SUBJECT: Forwards addl info re App R draft safety evaluation rept open items, per 870323 request.

BROWNS FERRY NUCLEAR PLANT (BFN) - 10 CFR 50, APPENDIX R

ENCLOSURE 1
BROWNS FERRY NUCLEAR PLANT
RESPONSE TO NRC REQUEST FOR ADDITIONAL INFORMATION
FROM MARCH 23, 1987 APPENDIX R MEETING IN BETHESDA, MARYLAND

Item 4.0.B.4 - Manual Actions in Fire Areas 4, 8, 9, 12, and 13

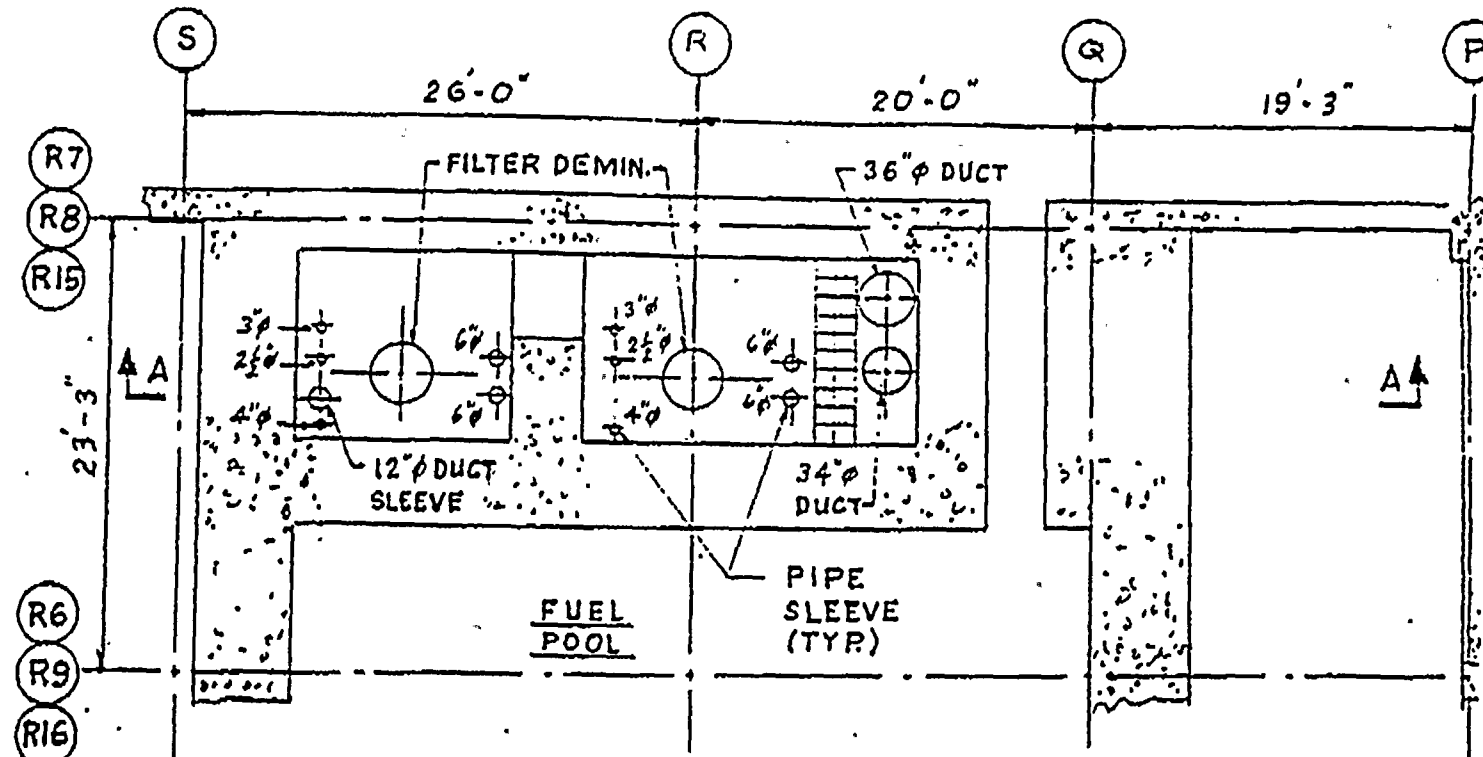
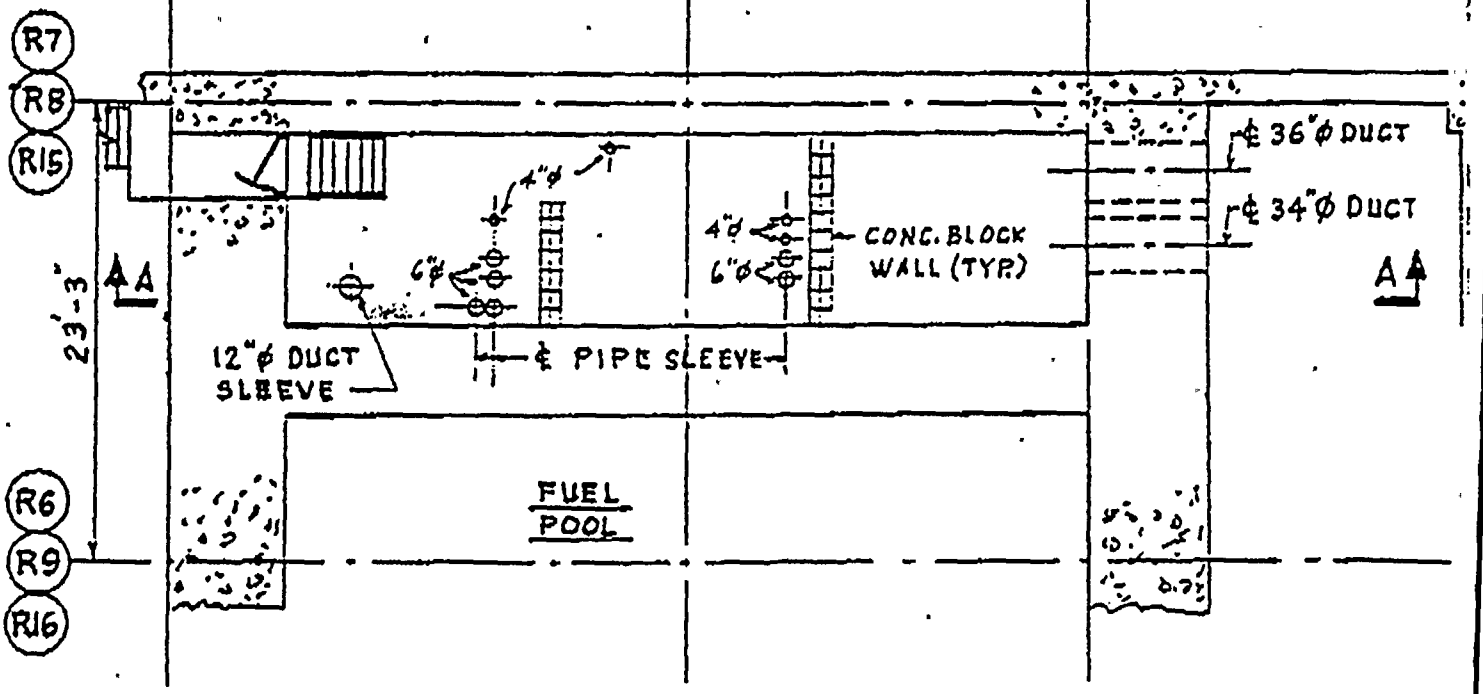
1. Confirm that the manual actions performed in these fire areas do not require cold shutdown repairs to accomplish.
2. Clarify what manual actions are performed in these fire areas.
3. Commit to correcting mistakes identified in manual action calculations (Enclosure 4 of November 21, 1986 submittal to NEDC 31119) for these fire areas.

Enclosure 4 of the November 21, 1986 submittal provided a table of manual actions for each fire area. The table for fire areas 4, 8, 9, 12, and 13 mistakenly identified an action to be performed on a potentially fire damaged circuit breaker. This error was identified during development of the operating procedure and will be corrected in manual action calculations. The valves will be disabled by verifying that power to the board is removed from its power source located in a different fire area. The valves are disabled to prevent spurious operation and allow the operator to manually position the valve using the local handwheel. No repair or repair procedure is required to obtain hot or cold shutdown conditions for these areas.
